Access Compliance Report

Public Rights-of-Way

Intersection ID: 11511	Main Street: E_18TH_ST	Cross Street: N_DAVIDSON_ST	Location: W
ADA ID: E4AF0E19B096	Ramp Type: PerpDiag	Initial Pass/Fail: Fail	Overall Compliance: No
		Severity Score: 25

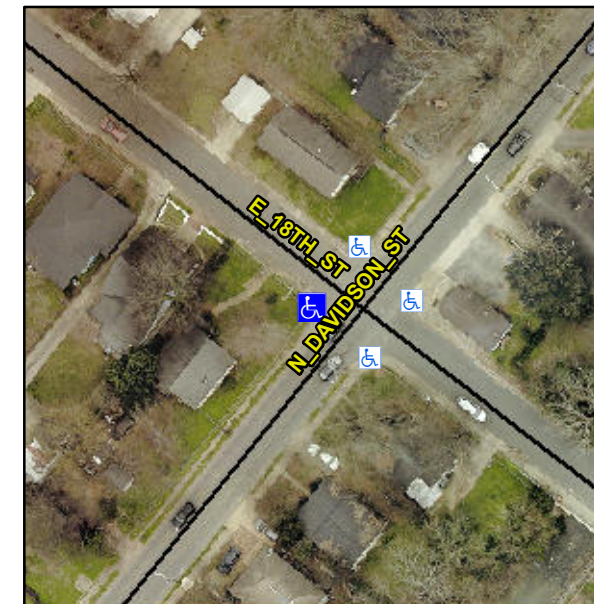
Not Found, R304.2.2

Compliance	Description	Data	Compliance	Description	Data
N/A	Ramp Length (in)	60.0	No	Ramp Slope (%)	14.8
Yes	Ramp Width (in)	50.0	Yes	Ramp XSlope (%)	1.5
N/A	Flare Type LT	N/A	N/A	Flare Type RT	N/A
N/A	Flare Slope LT (%)	N/A	N/A	Flare Slope RT (%)	N/A
N/A	Flare Traversable LT?	N/A	N/A	Flare Traversable RT?	N/A
N/A	Landing Length (in)	N/A	N/A	DWS Provided?	N/A
N/A	Landing Width (in)	N/A	N/A	DWS Contrast?	N/A
N/A	Landing Slope (%)	N/A	N/A	DWS Length (in)	N/A
N/A	Landing X Slope (%)	N/A	N/A	DWS Full Width?	N/A
N/A	Landing Curb? (Y/N)	N/A	N/A	DWS Offset (in)	N/A
N/A	Shared Landing?	N/A			
N/A	Gutter Ponding?	N/A	N/A	Gutter Slope (%)	N/A
N/A	Gutter Lip Ht (in)	N/A	N/A	Gutter X Slope (%)	N/A
N/A	Painted X Walk1?	No	N/A	Painted X Walk2?	No
	X Walk 1 Direction	To SE		X Walk 2 Direction	To NE
N/A	X Walk 1 Width (in)	N/A	N/A	X Walk 2 Width (in)	N/A
	X Walk 1 Slope (%)	2.3		X Walk 2 Slope (%)	0.3
	X Walk 1 X Slope (%)	1.1		X Walk 2 X Slope (%)	0.2

Remove & Replace Curb Ramp With Two New Directional Ramps or Equivalent.
